Drainage Compliance Note

Lutterworth Road, Burbage Phase 2

Ref: PJS21-065-DOC-02

As part of the full planning application for the Phase 2 development of Lutterworth Road, Burbage (ref: 24/00139/FUL) for the provision of an additional 23 homes, the Lead Local Flood Authority (LLFA) has provided consultation feedback recommending the following condition.

MicroDrainage Schematic

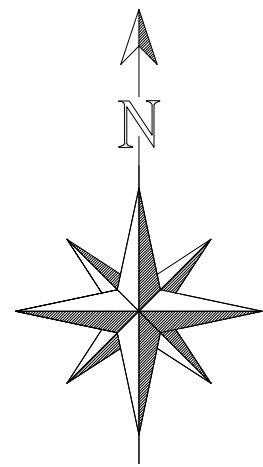
- 1. The hydraulic calculations provided for Networks 3 and 4 have been modelled in isolation with a free-flowing outfall. It is not considered representative of the real-life conditions to model the network without taking into consideration Phase 1. Downstream water levels will have an impact upstream. Please re-run the Phase 1 model, incorporating the Phase 2 drainage and provide the latest Section 104 drainage drawing for Phase 1.*

The LLFA requested in point 1 that the Phase 2 hydraulic model be integrated into the existing Phase 1 system in order to assess downstream water levels and their impact on the upstream network. In response, we have produced a combined hydraulic model. Supporting calculations can be found in **Appendix 1**.

To support this, a surface water drainage schematic has been included in **Appendix 2**, aligning pipe coding with the revised model inputs. The results demonstrate that the composite model of phase 1 & 2 networks performs within acceptable standards, with no flooding during a 1-in-30-year storm event.
